UNITED STATES
DEPARTMENT OF THE INTERIOR
BUREAU OF LAND MANAGEMENT

SUNDRY NOTICES AND REPORTS ON WELLS
Do not use this form for proposals to drill or to re-enter an abandoned well. Use Form 3160-3 (APD) for such proposals.

Opera AQG Federal 1

RE: Plugging and Abandonment Requirements, Conditions of Approval

WELLBORE AFTER PROPOSED ABANDONMENT

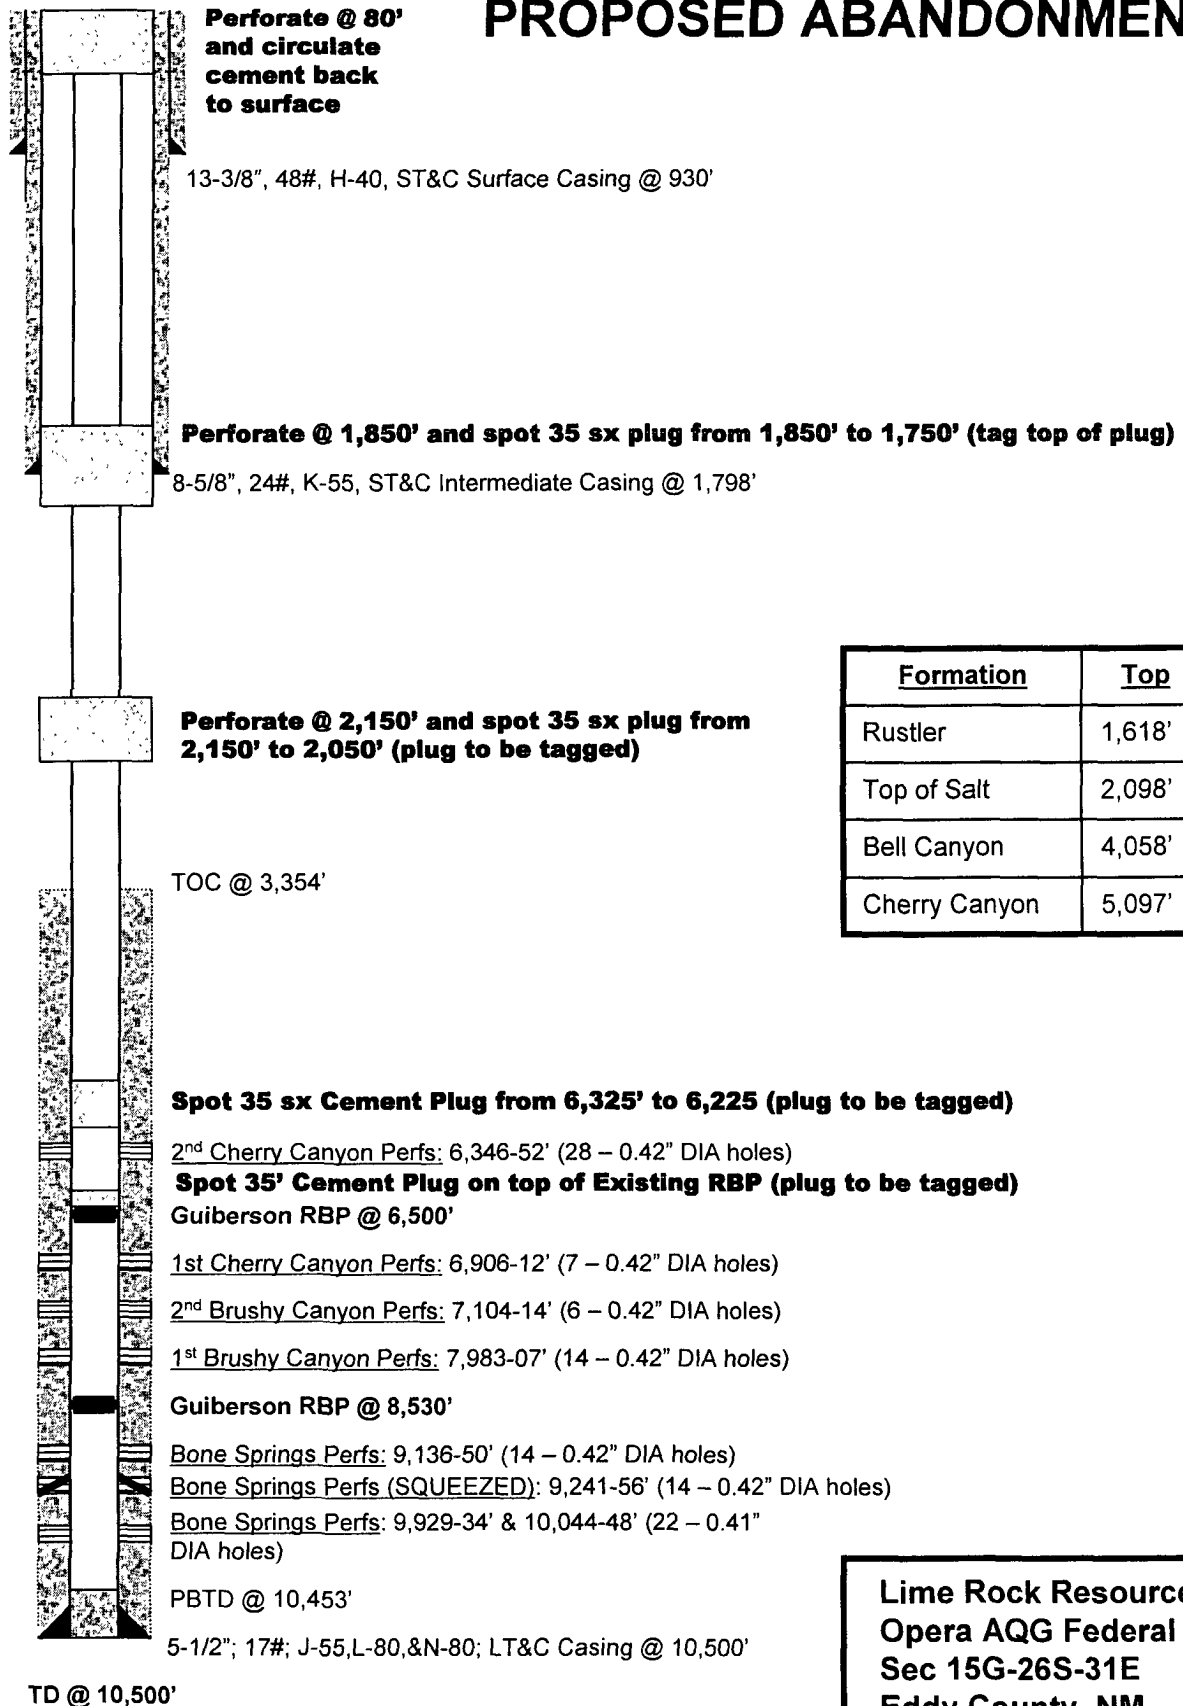
1. OK
2. Remove Guiberson RBP @ 6,500'. RIH and tag Guiberson RBP @ 8,530' and dump bail 35' cmt on top of plug.
3. Spot a 160' plug from 6,325'-6,165'.
4. Spot a 130' plug from 3,948'-3,818' (Base of Salt). WOC and tag.
5. Perforate @ 2,160', squeeze with adequate cmt to fill from 2,130'-2,040' (Top of Salt). WOC and tag.
6. Perforate @ 1,860', squeeze with adequate cmt to fill from 1,860'-1,740'. WOC and tag.
7. Perforate @ 980', squeeze with adequate cmt to fill from 980'-880'. WOC and tag.
8. Perforate @ 60' and circulate cmt to surface.
